This Service Information bulletin supersedes SI B13 14 10 **dated July 2013.**

Voluntary Emissions Recall Campaign 10E-A02: N54 Inspection and Replacement of Injectors

E60, E61, E71, E82, E88, E90, E92, and E93 with the N54 engine produced from 04/02/2007 through 11/30/2008

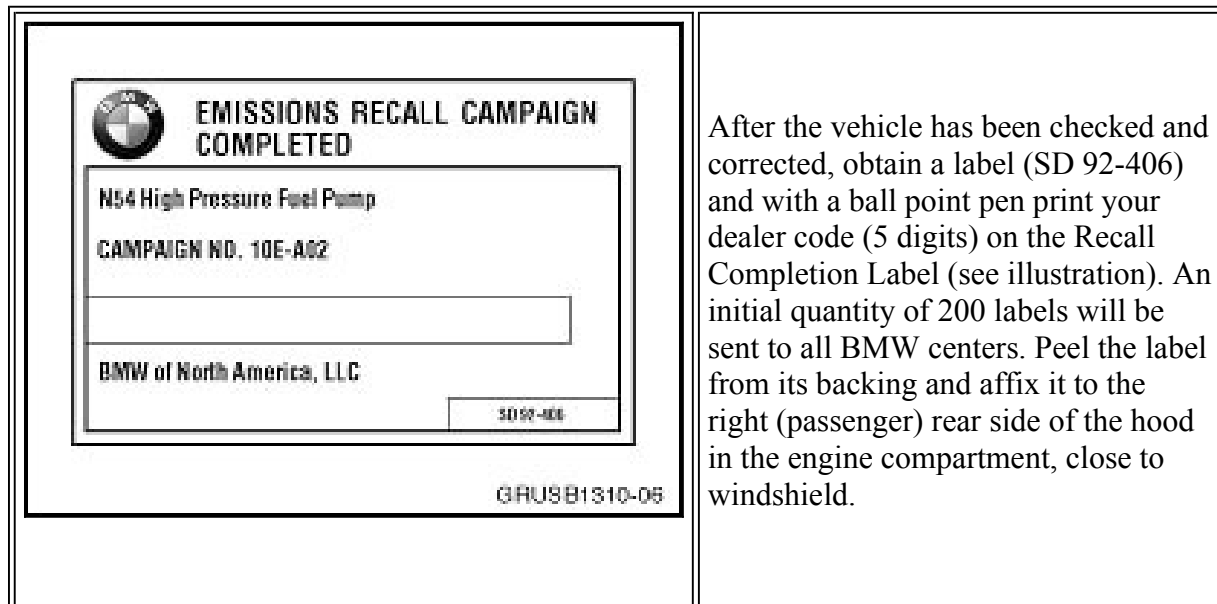
After the vehicle has been checked and corrected, obtain a label (SD 92-406) and with a ball point pen print your dealer code (5 digits) on the Recall Completion Label (see illustration). An initial quantity of 200 labels will be sent to all BMW centers. Peel the label from its backing and affix it to the right (passenger) rear side of the hood in the engine compartment, close to windshield.
